**7-D-22-HZ**  
**APPLICATION FOR CERTIFICATE OF APPROPRIATENESS**

**214 E. Scott Ave. 37917**  
**Old North Knoxville H**

# Staff Report

File Number: 7-D-22-HZ

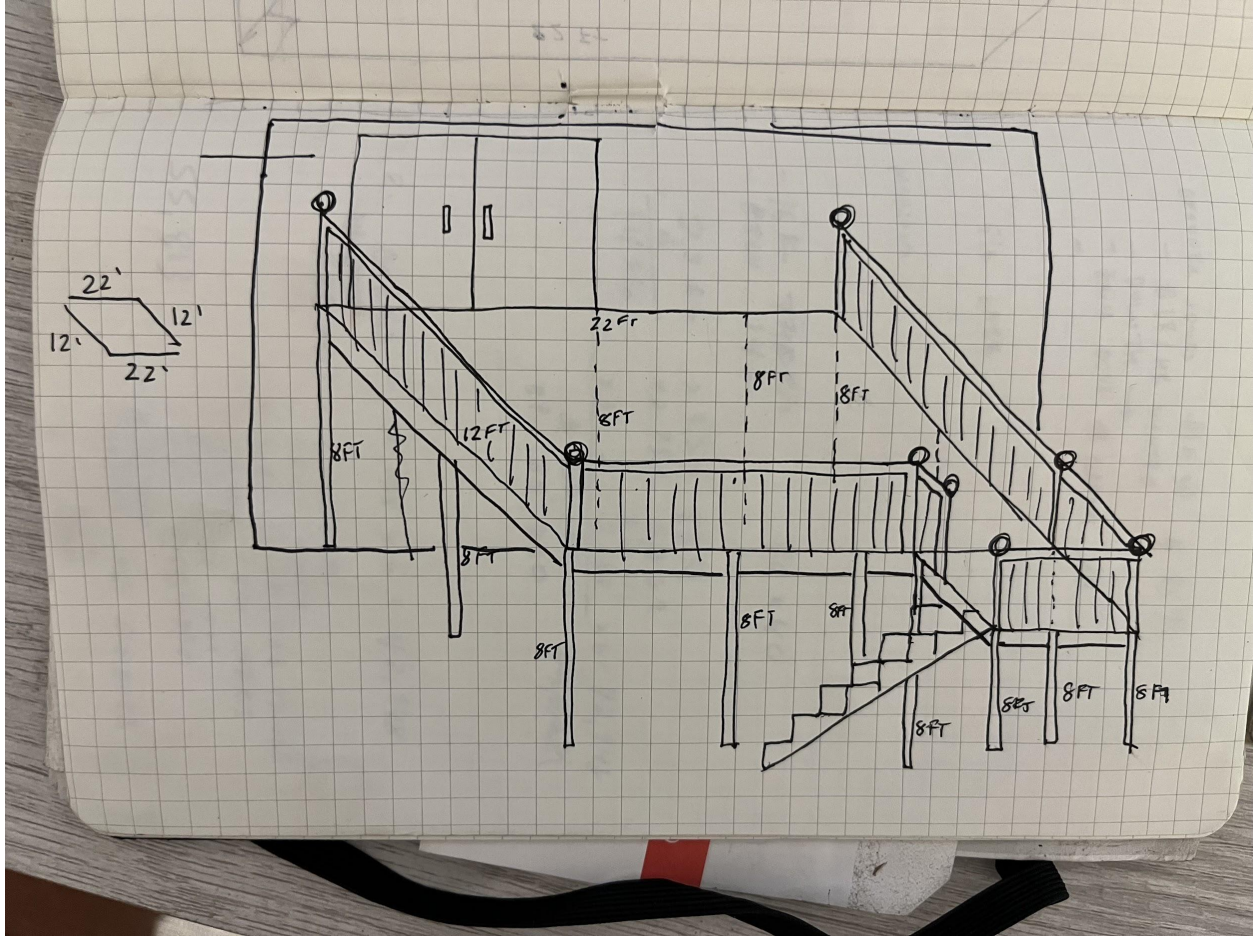
3. The rear section where windows were enclosed is a non-original rear shed-roof addition; most likely a porch which was enclosed. The windows were four adjoining six-light windows of unknown material, followed by three adjoining single-light windows of unknown material.

4. Replacing non-historic windows with wood, multi-light double doors can be appropriate on a rear elevation not visible from the primary street. The Commission may choose to discuss any additional transparency needed on the right side of the rear elevation (also enclosed with siding). The Commission requested a scaled and dimensioned drawing of the rear elevation to be submitted to the Commission at the August 2022 HZC meeting.

Staff recommends approval of the work as completed and proposed, providing for any additional rear elevation transparency or details recommended by the Commission.

Here is the existing footprint of the home with the addition of the deck.

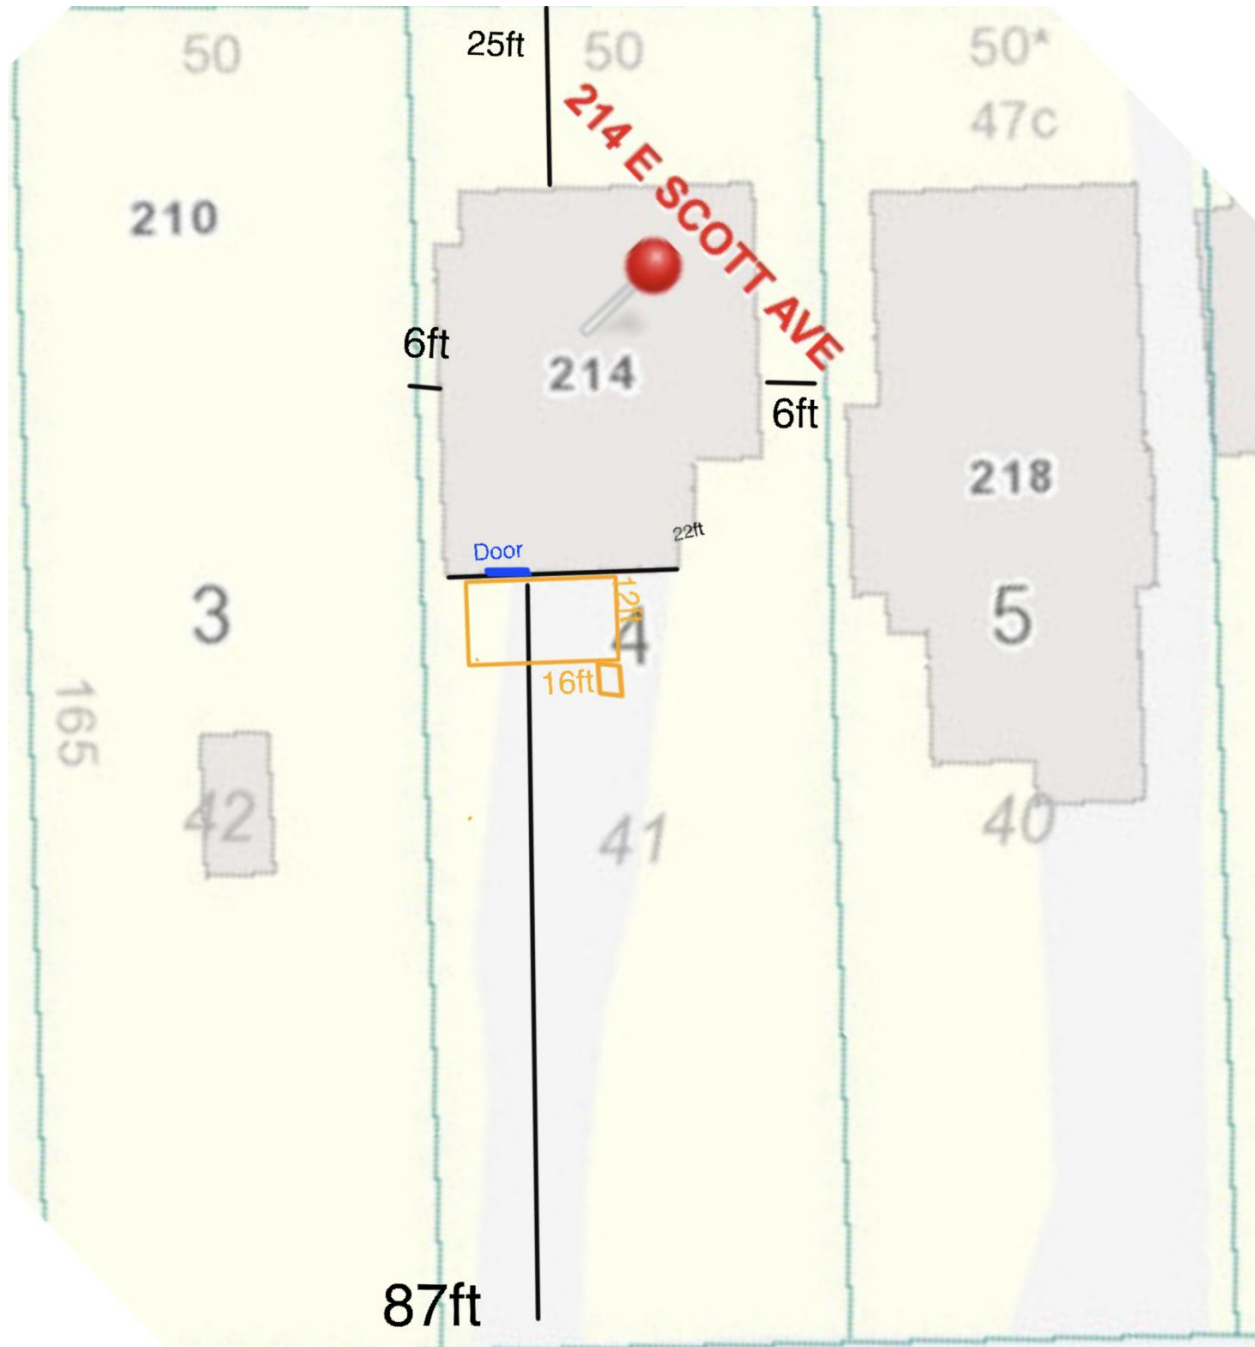
5. A rear wood deck with balusters set into the top and bottom rails meets the design guidelines.
